## Thor Motor Coach Technical Service Bulletin

TSB #	<b>TSB 21-01</b>		
Description/Title:	<b>120VAC load shedding</b>		
Affected Product Line(s):	<b>Certain model year 2021 Four Winds, Quantum, and Chateau motorhomes</b>		
Service Campaign # :	<b>RC000214</b>	Released Date:	<b>3/24/2021</b>
Codes:	<b>TMCTS80265W</b>	Document Date:	<b>3/24/2021</b>
Time Allowed:	<b>0.3</b>	Document Revision:	<b>A</b>

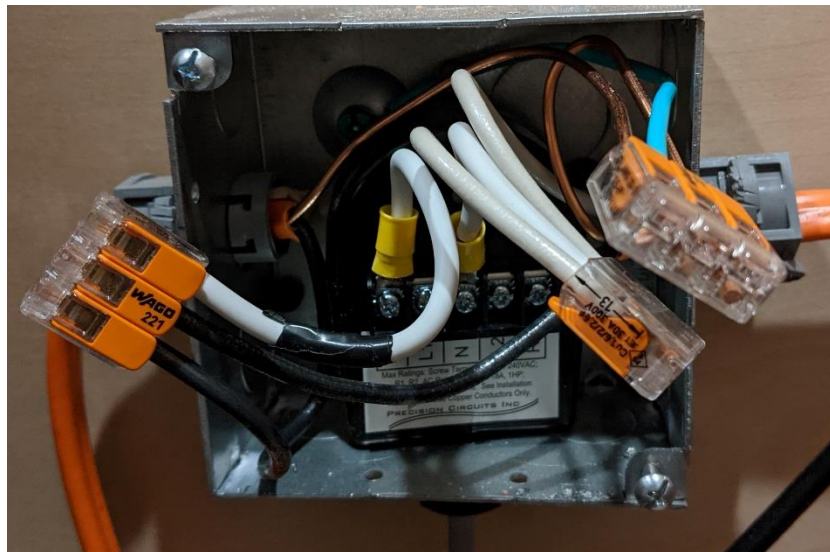
From November 2020 to February 2021, units produced at Plant 250 have a wire missing that would cause the 120VAC load shedding to not work properly. This affects model year 2021 31E, 31EV, 31W, 31WV, SL31, SE31, LF31, and WS31 floor plans with the 2 A/C option.

6. Connect the fork to L1 like is shown in the attached picture.

*(Note: White wire with black tape in above photo represents the black wire being added during this TSB.)*

1. Crimp the yellow #6 fork terminal on one end of the wire and the WAGO connector needs to be attached on the other end.
2. Turn the main 30A 120VAC breaker off in the electrical load center.
3. Remove the cover from the metal junction box located behind the electrical load center.
4. There will already be two black wires in the metal junction box connected with a 2 way WAGO connector.
5. Remove the 2 way WAGO connector and put the two black wires into the two open spots in the 3 way WAGO connector on the 6" black wire. Flip down the orange levers.

7. Reinstall cover on metal junction box.

**To test if fix worked, plug into shore power.  
Hit the “Select” button on the Power Control System display panel until you see “Service” on the display. Below Service it should show “30A”.**
